Mad Rabbit Compromise Proposal Summary

Keep Routt Wild

June 9, 2022

A map of the 2019 Mad Rabbit Trail Segments is also shown below.

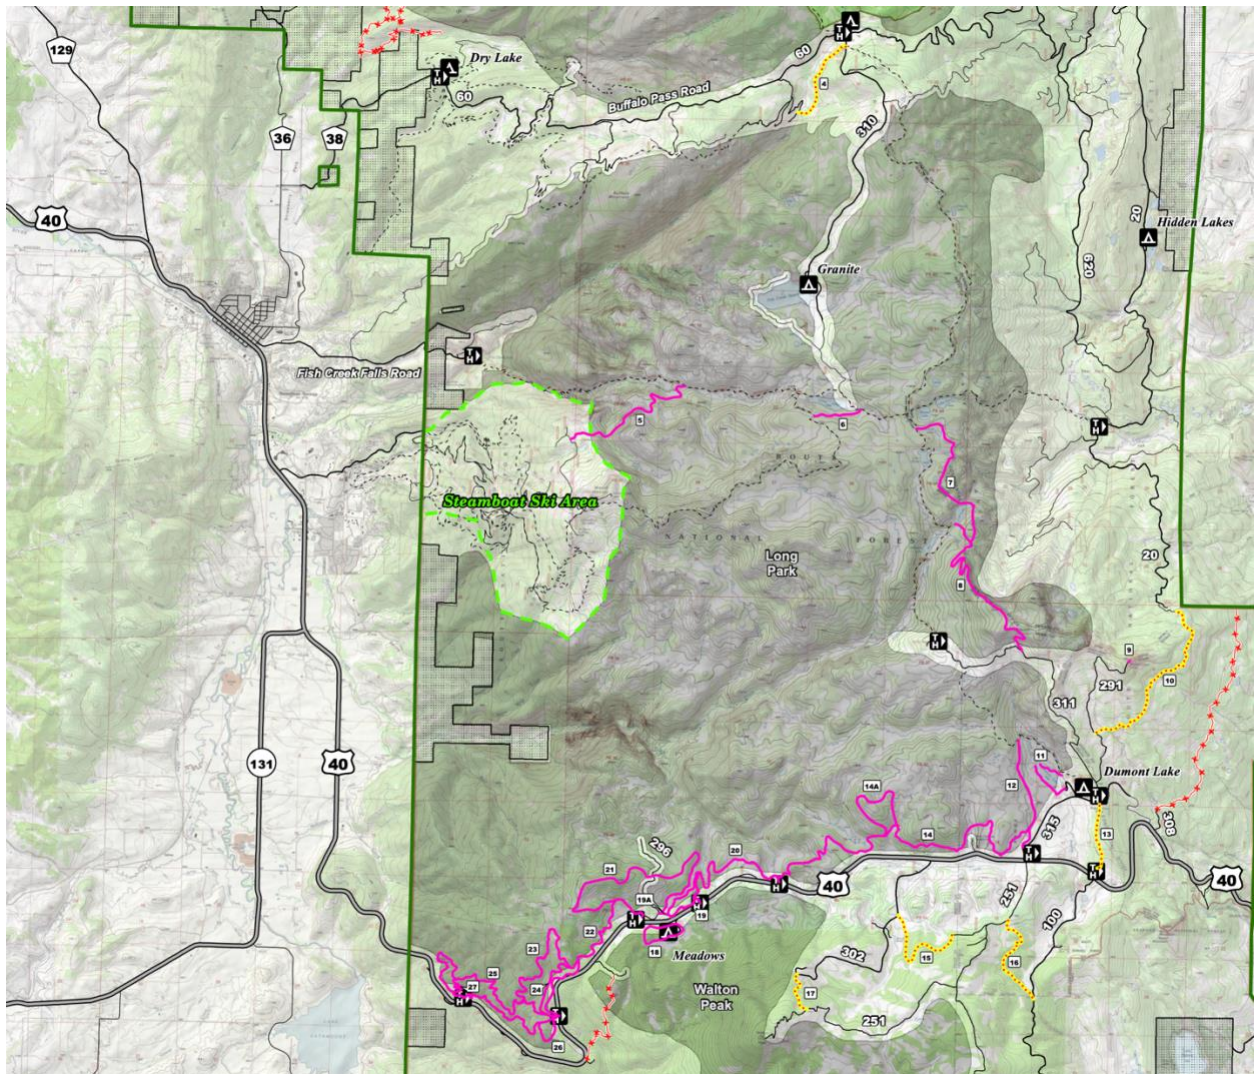
OHV Trails (shown as yellow with black dots): We endorsed all OHV trails except Trail #10, which is problematic due to its connectivity. This connectivity will dramatically increase OHV traffic through elk summer range and should be eliminated.

-Trails 19, 19A, 20, and 14 are the essential components to an epic trail experience. We support the purpose of these trails, but they should be moved to the south of US40. This removes them from CPW-indicated elk calving areas as well as the Long Park CRA. We have recommended this for some time. To our knowledge, no investigation of this alternative has been performed by the Forest Service. Since it is impossible to start construction of Mad Rabbit trails this year, summer offers an opportunity to investigate a southern routing with minimal impact to the Mad Rabbit schedule. We believe that investigation of this alternative is compelled under NEPA.

-Trail 21 routes too deeply into the CRA and traverses elk calving areas. It should be eliminated.

-Trail 14A is a loop deep into a CRA and traverses an elk calving area. It should be eliminated.

-Trail 12 is unneeded, intrudes into a CRA, and should be eliminated or routed adjacent to the Dumont Lake access road.

Campground Trails (Trails 18 and 11): We endorse the trails at Meadows and Dumont Lake. However, the planners need to be very careful of trail impact at the Dumont Lake inlet and outlet due to the wetlands there.

Continental Divide Trails: Adding Trails 7 and 8 will create loops that will lead to a) increased user conflict, b) altering the undeveloped characteristics of the Long Park CRA, c) creating islands of habitat loss and fragmentation in elk summer range, and d) increased maintenance costs. There should be no loops along the CDT. However, if the USFS prefers another location

Long Lake Bypass: We have no objections to Trail 6, the Long Lake Bypass.

Fish Creek: Trail 5 is very problematic. First, there is no current user conflict on the current Fish Creek trail, bringing the purpose and need of this trail into question. However, the new trail connects to the ski area and brings new users into an area of the Long Park CRA not currently impacted by humans. It also represents a NEPA connected action with the Ski Area Expansion in that area. It should be eliminated.

Ferndale/Trails west of West Summit: This dense network of trails (Trails 22 through 27) is problematic and should be eliminated. These are trails are a) high density (4.9miles/sq-mile), b) difficult to enforce trail closures, c) include elk calving areas, d) heavily impact the undeveloped characteristic of a CRA, and e) have severe parking issues. The expected user densities of these trails are likely to exceed the limits of primitive and semi-primitive trails, and thus exceed the user density defined for Colorado Roadless Areas. Please note that the Colorado Roadless Rule states that any development that significantly alters the undeveloped characteristic of a Colorado Roadless Area automatically triggers an EIS.
